PLANT NAME: OCONEE # 1

PROPOSED CHANGES TO TECH. SPECS ASSURING OPER-
ATION OF THE CYCLE 4 CORE WITHIN APPLICABLE
FUEL DESIGN AND PERFORMANCE CRITERIA ...W/
REPLACEMENT PAGES AND RELOAD REPORT...

Re: Oconee Unit 1
Docket No. 50-269

Pursuant to 10CFR50, §50.90, please find attached proposed changes to the Oconee Nuclear Station Technical Specifications. The purpose of these revisions is to assure operation of the Oconee Unit 1, Cycle 4 core within applicable fuel design and performance criteria. The proposed changes are shown in Attachment 1 as replacement pages for the Oconee Nuclear Station Technical Specifications:

Figure 2.1-1A

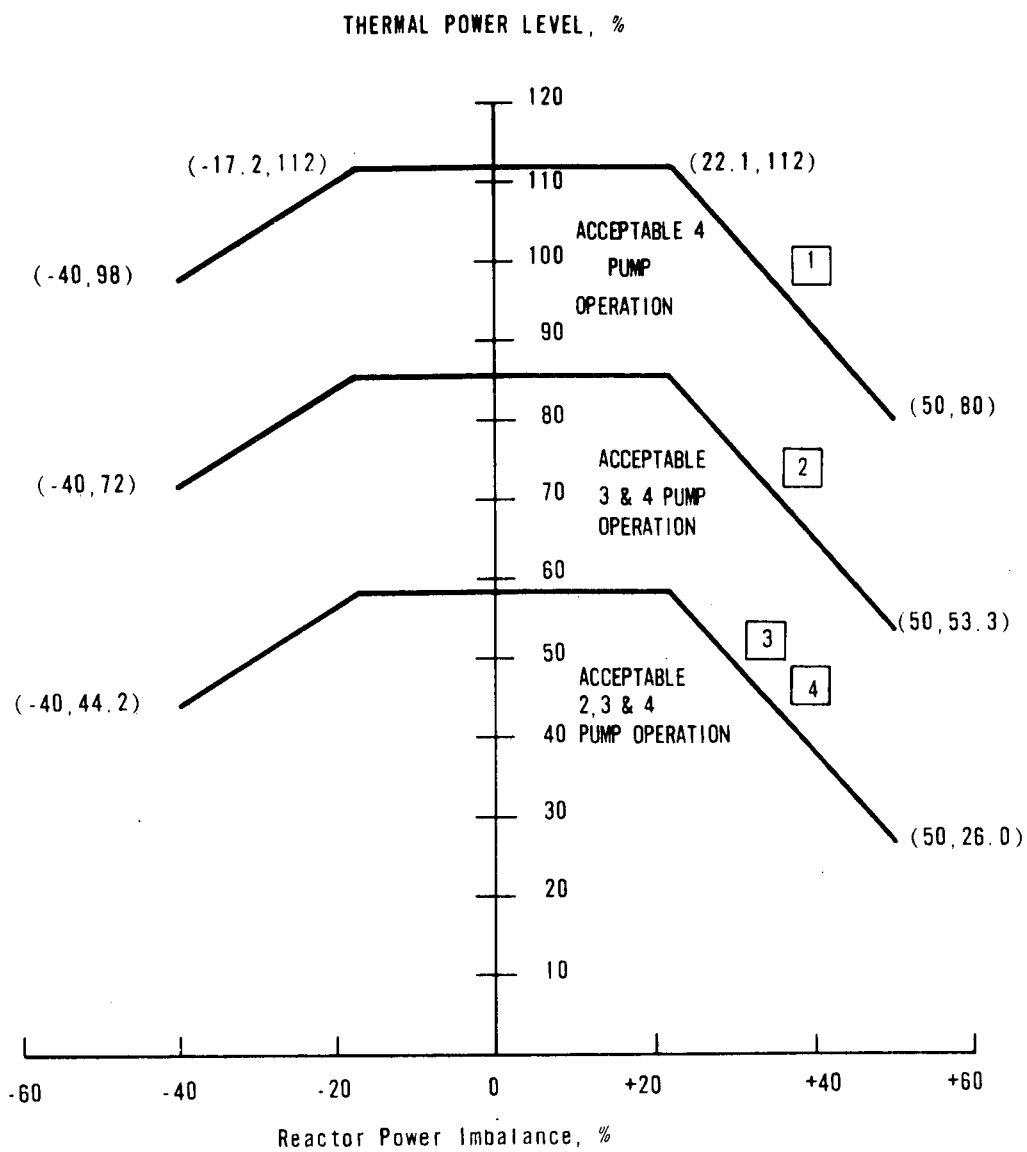
The curve presented in Figure 2.1-1A represents the conditions at which a minimum DNBR of 1.30 is predicted for the maximum possible thermal power (112 percent) when four reactor coolant pumps are operating (minimum reactor coolant flow is 106.5 percent of 131.3×10^6 lbs/hr.). This curve is based on the combination of nuclear power peaking factors, with potential effects of fuel densification and rod bowing, which result in a more conservative DNBR than any other shape that exists during normal operation.

Figure 2.1-2A

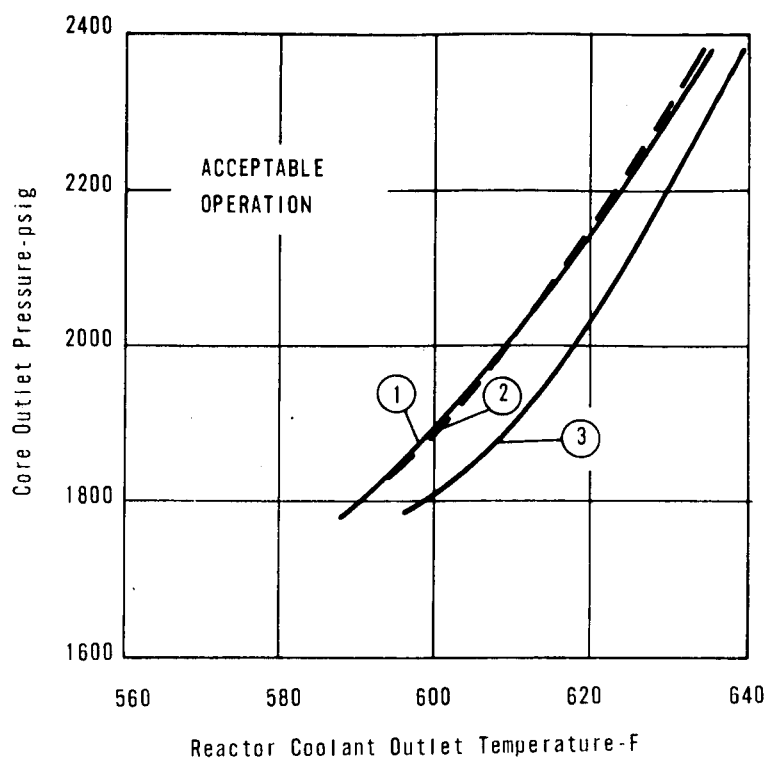
The curves of Figure 2.1-2A are based on the more restrictive of two thermal limits and include the effects of potential fuel densification and rod bowing:

1. The 1.30 DNBR limit produced by the combination of the radial peak, axial peak and position of the axial peak that yields no less than a 1.30 DNBR.
2. The combination of radial and axial peak that causes central fuel melting at the hot spot. The limit is 20.15 kw/ft for Unit 1.

The specified flow rates for Curves 1, 2, 3 and 4 of Figure 2.1-2A correspond to the expected minimum flow rates with four pumps, three pumps, one pump in each loop and two pumps in one loop, respectively.

Figure 2.3-2A

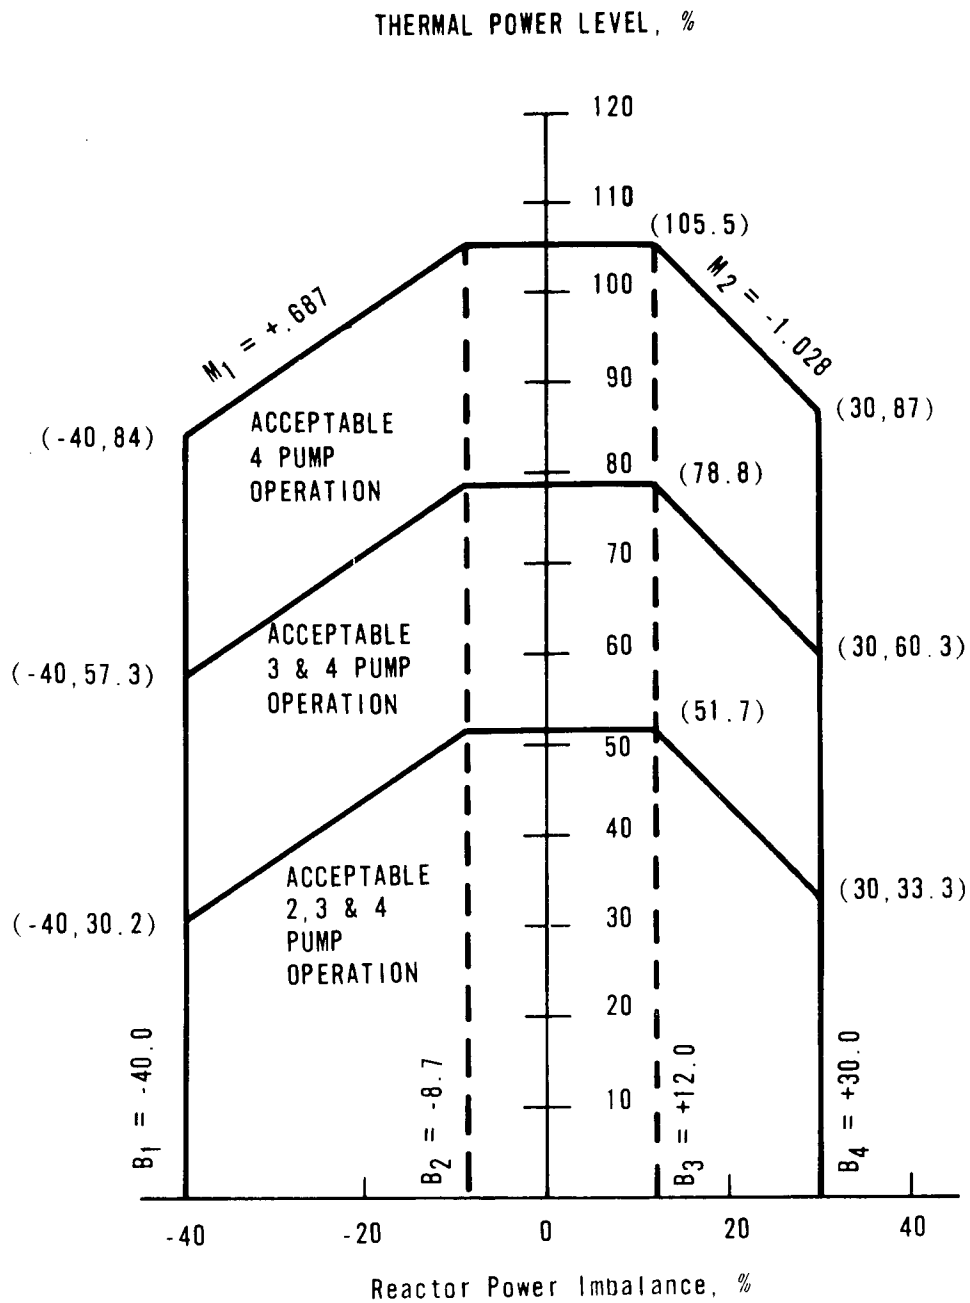
The power-imbalance boundaries are established in order to prevent reactor thermal limits from being exceeded. These thermal limits are either power peaking kw/ft limits or DNBR limits. The reactor power imbalance (power in the top half of core minus power in the bottom half of core) reduces the power level trip produced by the power-to-flow ratio such that the boundaries of Figure 2.3-2A - Unit 1 are produced. The power-to-flow ratio reduces the power

level trip and associated reactor power/reactor power-imbalance boundaries by 1.055%-Unit 1 for a 1% flow reduction.
